Access Compliance Report

Public Rights-of-Way

(Curb Ramps)

Intersection ID: 44555	Main Street: UNIVERSITY_CITY_BV	Cross Street: N_TRYON_ST	Location: SW
ADA ID: A8EF2E3FA537	Ramp Type: Perp	Initial Pass/Fail: Fail	Overall Compliance: No
		Severity Score: 1.25

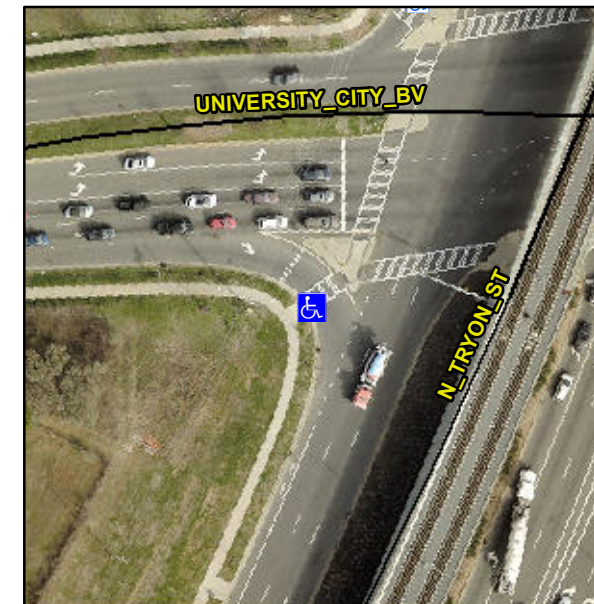
Not Found, R304.5.3

Compliance	Description	Data	Compliance	Description	Data
N/A	Ramp Length (in)	96.0	Yes	Ramp Slope (%)	7.8
Yes	Ramp Width (in)	91.0	No	Ramp XSlope (%)	3.8
N/A	Flare Type LT	N/A	N/A	Flare Type RT	N/A
N/A	Flare Slope LT (%)	N/A	N/A	Flare Slope RT (%)	N/A
N/A	Flare Traversable LT?	N/A	N/A	Flare Traversable RT?	N/A
N/A	Landing Length (in)	N/A	N/A	DWS Provided?	N/A
N/A	Landing Width (in)	N/A	N/A	DWS Contrast?	N/A
N/A	Landing Slope (%)	N/A	N/A	DWS Length (in)	N/A
N/A	Landing X Slope (%)	N/A	N/A	DWS Full Width?	N/A
N/A	Landing Curb? (Y/N)	N/A	N/A	DWS Offset (in)	N/A
N/A	Shared Landing?	N/A			
N/A	Gutter Ponding?	N/A	N/A	Gutter Slope (%)	N/A
N/A	Gutter Lip Ht (in)	2.0	N/A	Gutter X Slope (%)	N/A
N/A	Painted X Walk1?	Yes	N/A	Painted X Walk2?	N/A
	X Walk 1 Direction	To NE		X Walk 2 Direction	N/A
N/A	X Walk 1 Width (in)	127.0	N/A	X Walk 2 Width (in)	N/A
	X Walk 1 Slope (%)	7.3		X Walk 2 Slope (%)	N/A
	X Walk 1 X Slope (%)	1.6		X Walk 2 X Slope (%)	N/A

Remove & Replace Entire Ramp.
